**PROPOSED WAREHOUSE DEVELOPMENT
LOT 502 HOMESTEAD DRIVE, STAPYLTON**

The following information is provided in response to the following transport related item raised by Council in its Information Request MCU/2022/242 dated 23 June 2022:

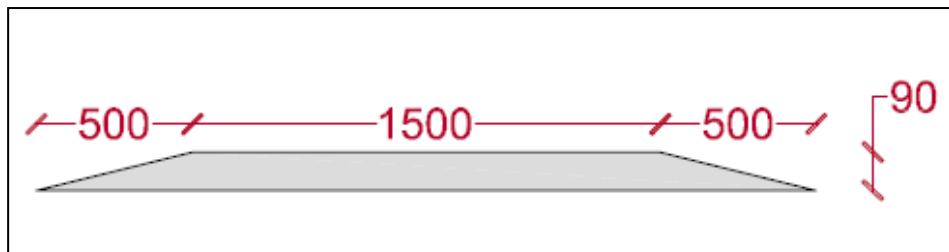
4. Raised pedestrian/cyclist pathway

To ensure compliance with M38 Industrial Estate Place Code Performance criteria PC41 and Car parking, Access and Transport Integration code Performance criteria PC12 and PC19 amended drawings must be submitted showing raised pedestrian pathways through the staff car park to help slow traffic and prioritise pedestrian safety. In accordance with AS2890.1 Section 2.3.3, the primary concern with aisle lengths greater than 100m is the need to manage traffic speed. Given effective aisle lengths up to 120m are proposed, traffic control devices, such as speed humps must be introduced to ensure internal traffic and pedestrian safety.

It is proposed that raised speed platforms be provided as suggested. The proposed section and dimensions are shown below. These are shown on the amended site plan.
